*TOLEDO CITY
PLAN COMMISSION
REPORT*

August 11, 2016

**TOLEDO-LUCAS COUNTY PLAN COMMISSIONS
APPLICATION DEADLINE, AGENDA, STAFF REPORT AND HEARING
SCHEDULE - 2016**

LANDSCAPE PLAN
SHEET 2

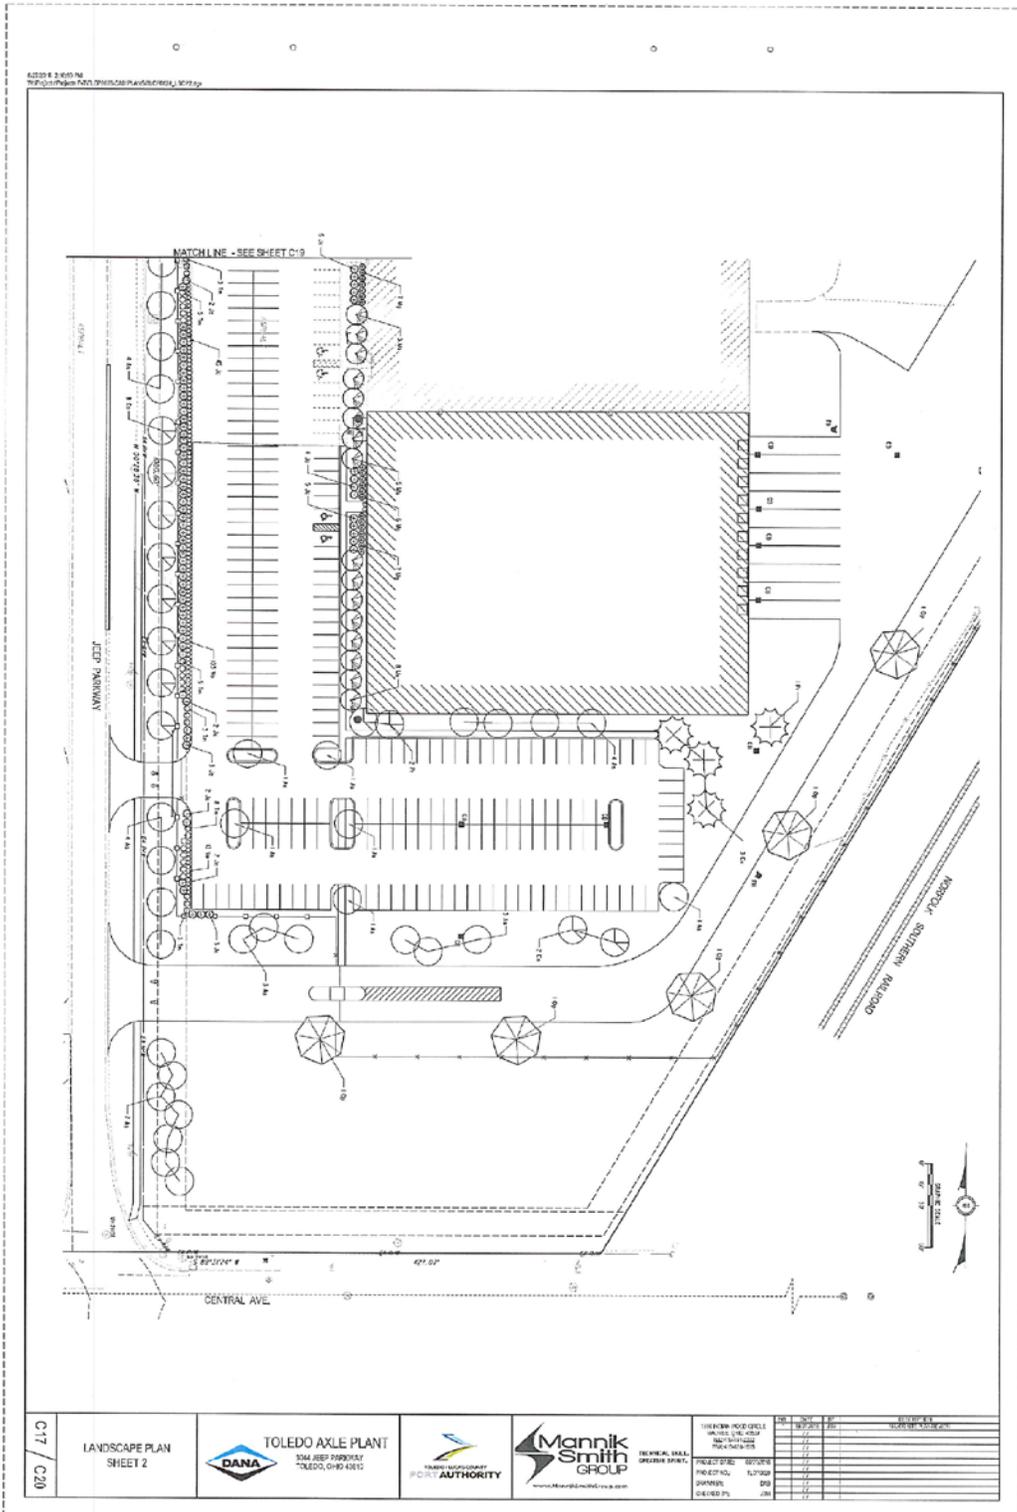
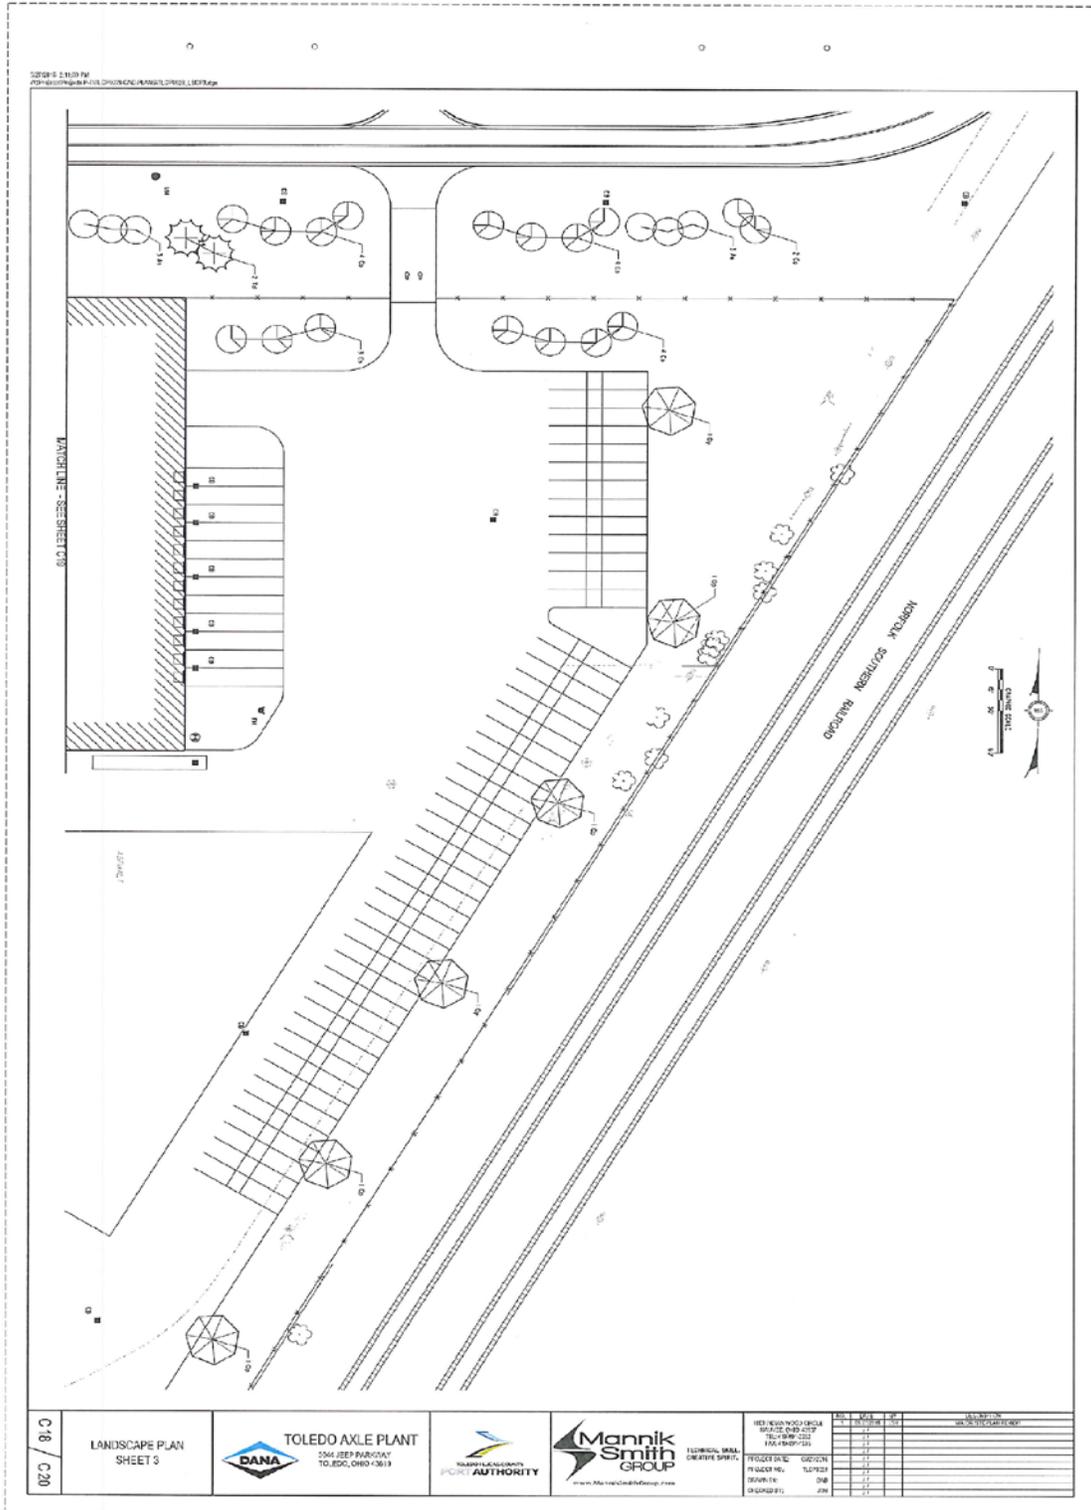
The landscape plan submitted depicts a thirty-foot (30') frontage greenbelt with landscaping and a six-foot (6') aluminum fence, requiring a variance, to screen the proposed parking lot. Additionally, a twelve-foot (12') retaining wall is proposed in the northwest portion of the site along the roundabout on Jeep Parkway. A variance of TMC§1105.0303(A)(1), through the Board of Zoning Appeals, will be required to allow for the proposed six-foot (6') aluminum fence and twelve-foot (12') retaining wall to be installed within the required thirty (30) foot front setback.

The applicant has provided a landscape plan that offers thirty-eight (38) trees and three hundred eighty (380) shrubs in the frontage greenbelt. Additionally, the site plan also indicates that plantings will be installed along the foundation of the buildings and along all perimeter property lines. The landscape plan offers the appropriate amount of trees and shrubs and is acceptable as submitted.

- a. A thirty-foot (30') greenbelt is required along the Jeep Parkway frontage, and shall include a solid evergreen hedge planting and one tree per every 30 feet of frontage; **acceptable as depicted on landscape plan.**
